Notice of Allowability	Application No.	Applicant(s)		
	10/523,411	SHIMIZU, HIROSHI		
	Examiner	Art Unit		
	Loha Ben	2873		
The MAILING DATE of this communication apperall claims being allowable, PROSECUTION ON THE MERITS IS herewith (or previously mailed), a Notice of Allowance (PTOL-85) NOTICE OF ALLOWABILITY IS NOT A GRANT OF PATENT RI	(OR REMAINS) CLOSED in this app or other appropriate communication GHTS. This application is subject to	olication. If not include will be mailed in due	ed course. THIS

EXAMINER'S AMENDMENT

Hiroshi SHIMIZU Q86093
LENS HOLDING JIG
Date Filed: February 3, 2005
Brett S. Sylvester (202) 293-7060
9 of 11

Fig. 10

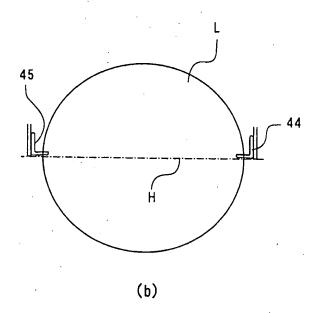
Figs. 9 and 10 have been labeled - PRIOR ART ---.

The following is an examiner's statement of reasons for allowance: The invention of the independent claim 1 (Fig. 1) is similar to the invention of the prior art (Figs. 9 and

10) contained in the present application, except that the prior art fails to teach or fairly suggest the limitation regarding the vertical extension which is to be in contact or highly close to the edge of the lens. With this characteristic in place, a solution film is prevented from occurring (see page 7, lines 5-8). This is an improvement over the prior art. As regards the embodiment of independent claim 7, the improvement can be achieved by a new type of lower side holder as given in last four lines of the claim, with the improvement being the reduction of amount of solution to be gathered on the lens (see page 8, lines 13-18).
